AGENDA
CASCADE CHARTER TOWNSHIP PLANNING COMMISSION
MONDAY, MAY 6, 2024
7:00 PM
2870 JACKSMITH AVE SE

PLANNING COMMISSION STAFF REPORT

STAFF REPORT: Case #23-3804
REPORT DATE: April 24, 2024
PREPARED FOR: Cascade Charter Township Planning Commission
MEETING DATE: May 6, 2024
PREPARED BY: Andrea Hendrick, Planning Director

REQUESTED ACTION: Site Plan Review for a new office building.

SITE PLAN FOR
6660 OLD 28TH STREET
CASCADE TOWNSHIP, KENT COUNTY, MICHIGAN

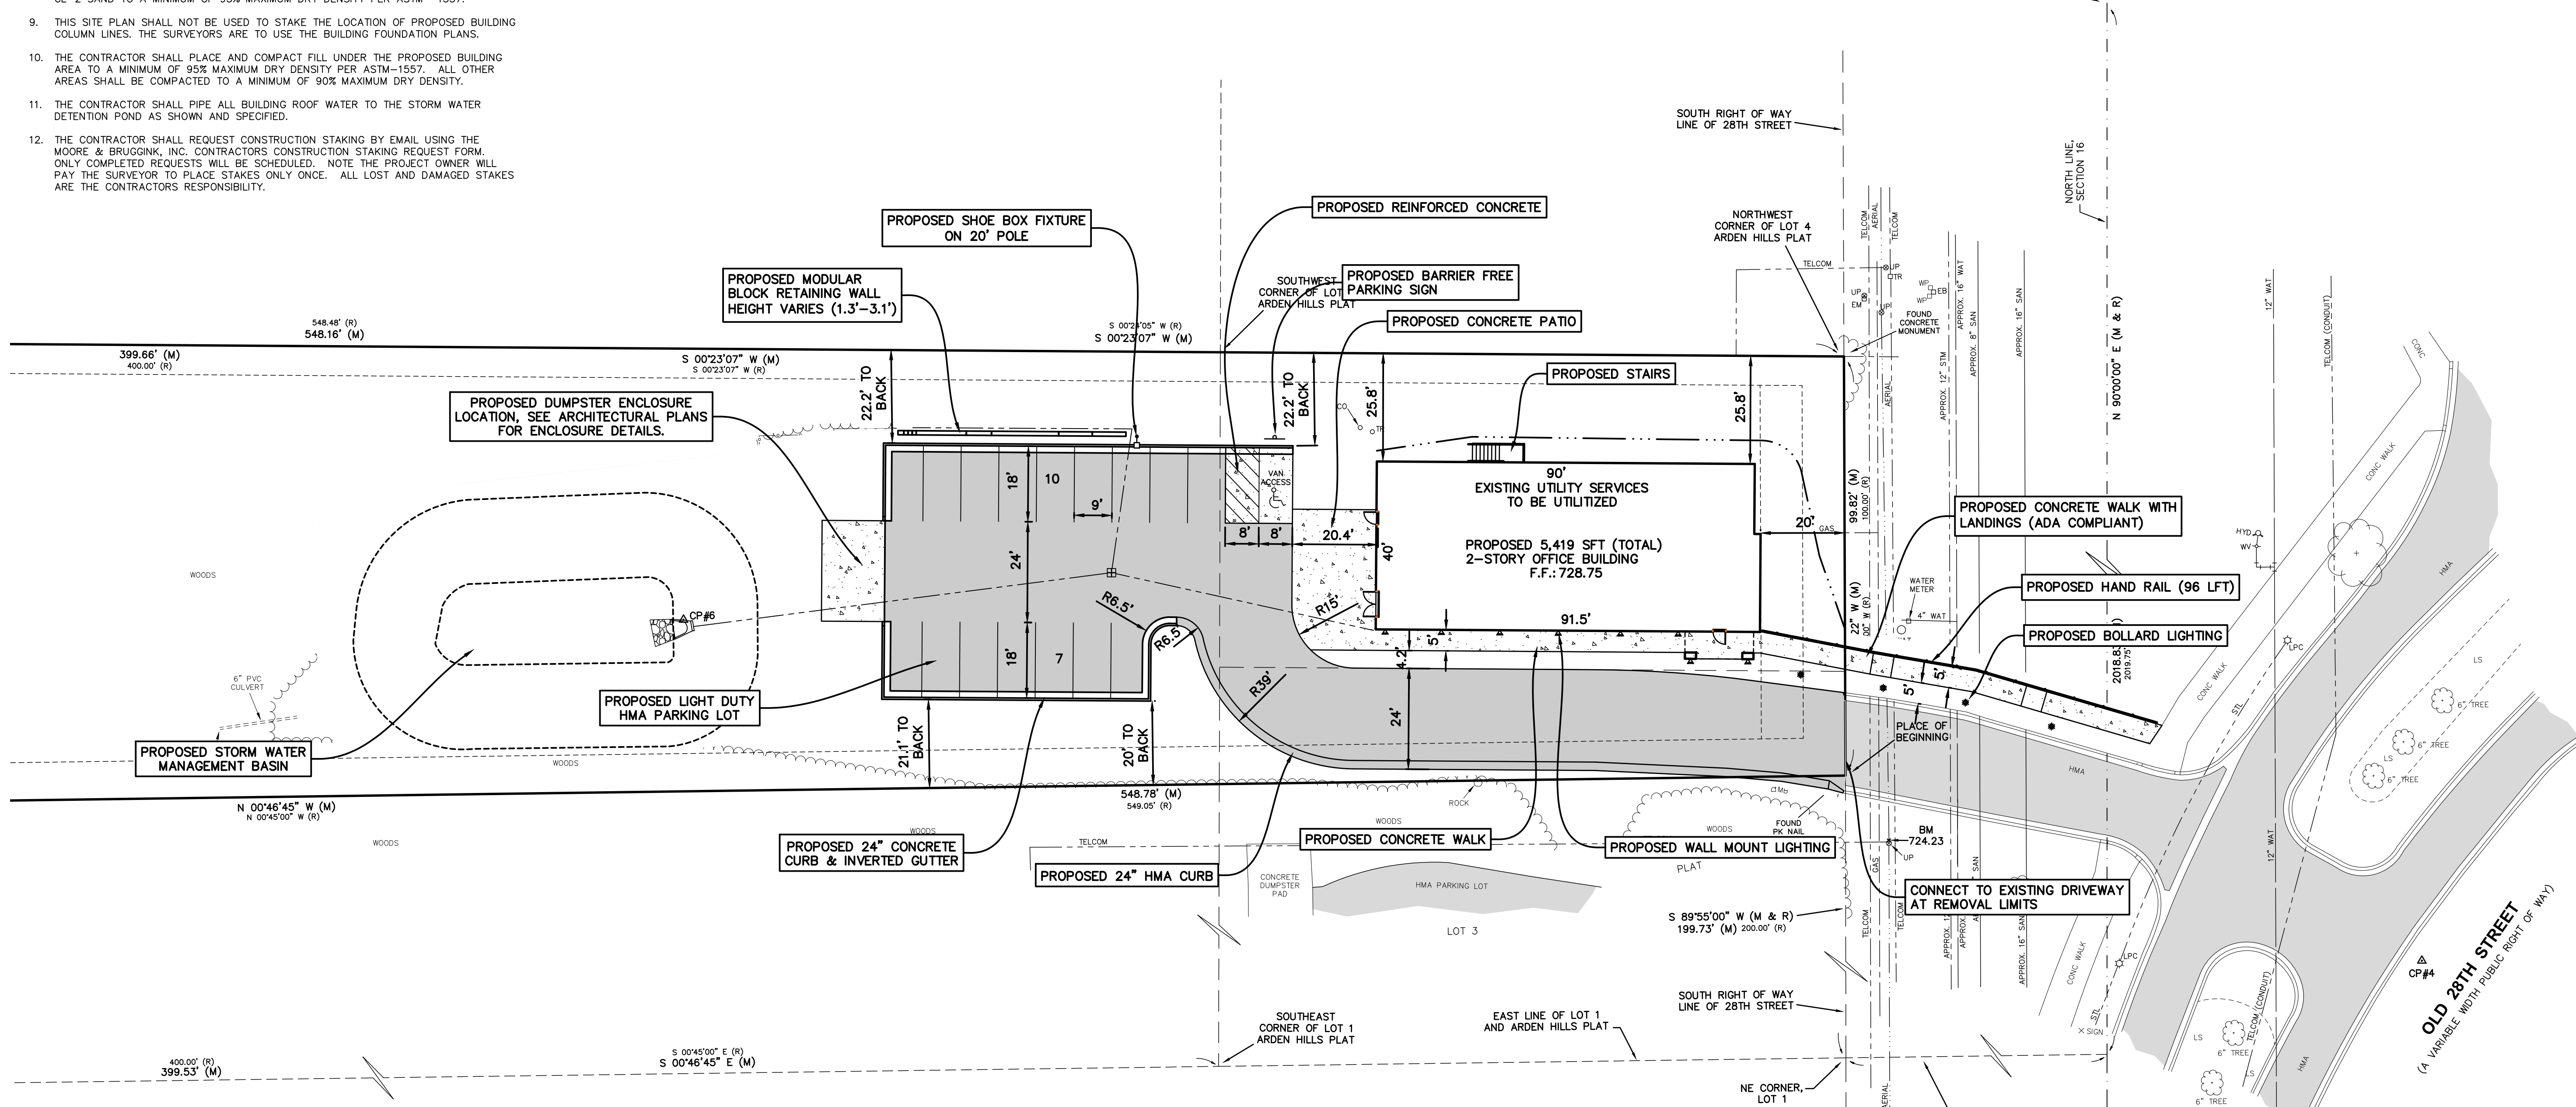
Bicycle Facilities: No bicycle rack is proposed on the site plan. The applicant should add a bicycle rack in accordance with the standards, as a condition of approval.

The site plan indicates 16 regular parking spaces measuring 18 feet x 9 feet and 1 handicap parking space that is double-wide, for a total of 17 parking spaces. The number of parking spaces are compliant with the standard.

(KCRC). It also appears that a portion of the curb and drive for ingress-egress is on the parcel to the east. The applicant should clarify why the access drive appears in the site plan on the parcel to the east (6990 Old 28th Street).

LANDSCAPE PLAN
FOR
6660 OLD 28TH STREET
CASCADE TOWNSHIP, KENT COUNTY, MICHIGAN

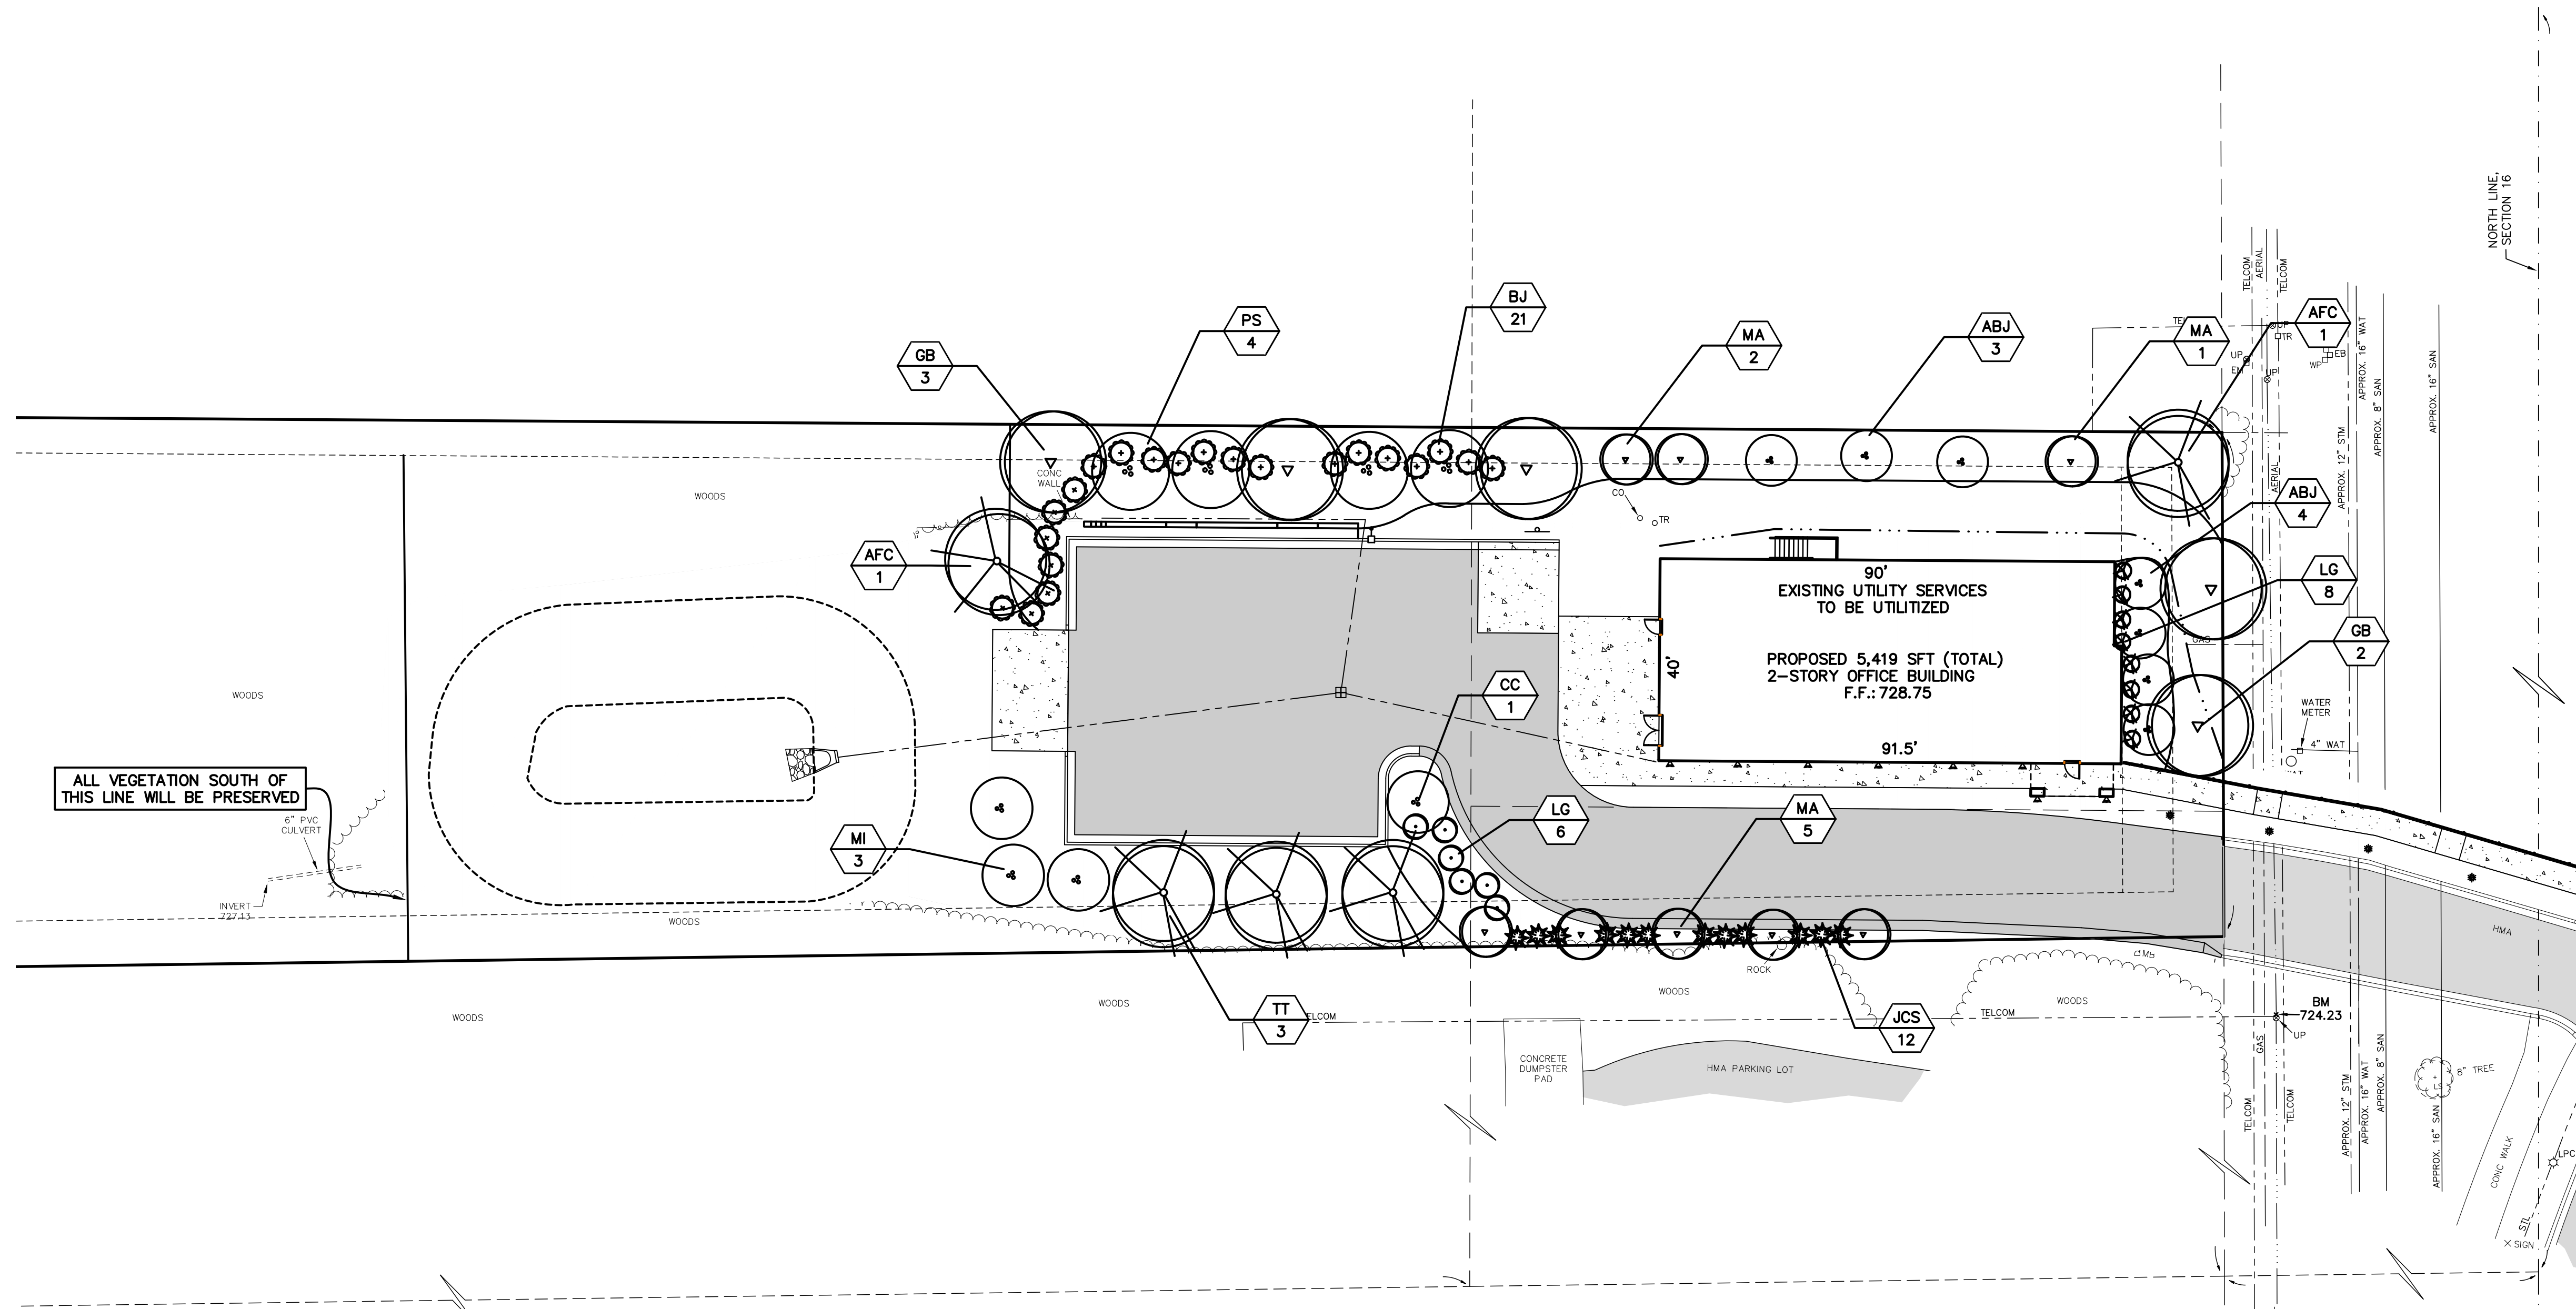
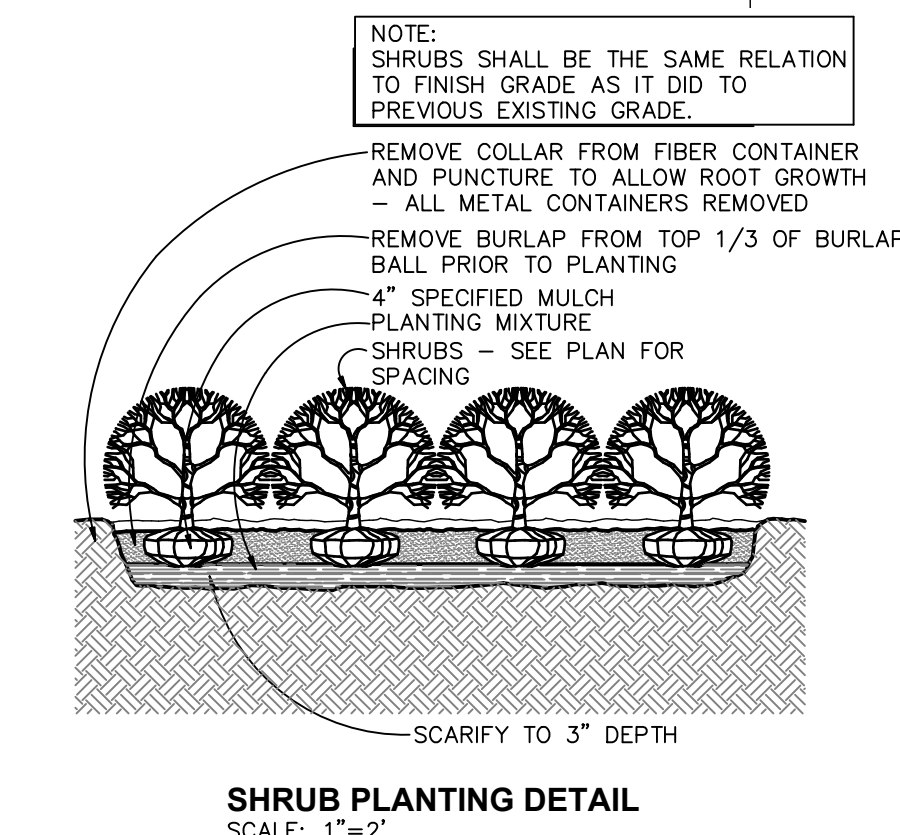
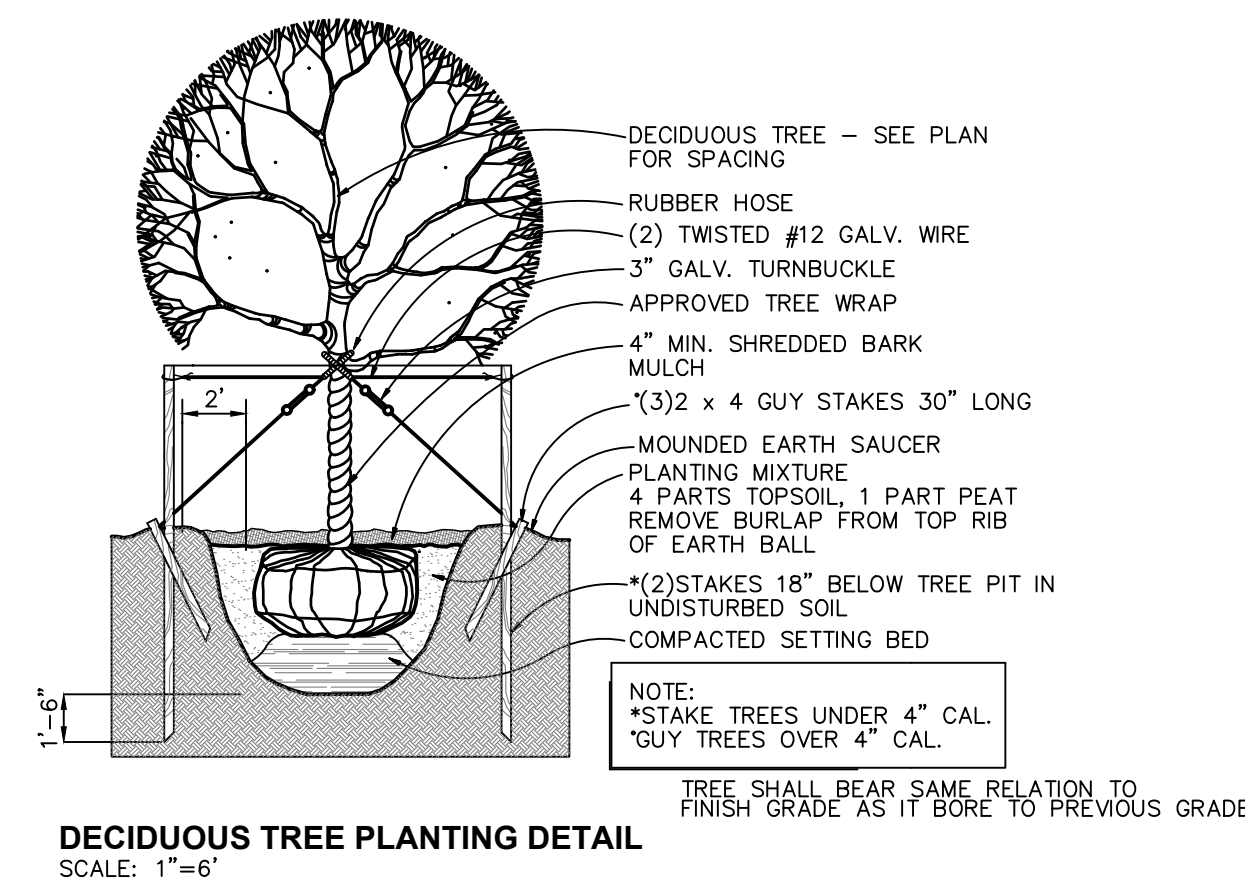
The site plan indicates a 20-foot bufferyard around the perimeter of the parcel. Along the east side of the parcel the access drive encroaches in the bufferyard. Section 18.15 grants an exception to bufferyard standards for this purpose. A majority of south portion of the parcel is preserved vegetation, with wooded areas in the bufferyard along the east and west sides, behind the building. Along the parking lot and building, the landscaping schedule provided below is proposed in the Landscaping Plan on page 6’s Plant List.

The landscaping plan for the subject site is in compliance with the bufferyard and landscaping standards. None of the proposed trees are ‘undesirable’, in accordance with Table 20-E. A Landscape Bond of \$5,000 shall be submitted prior to construction. This is a condition of approval.
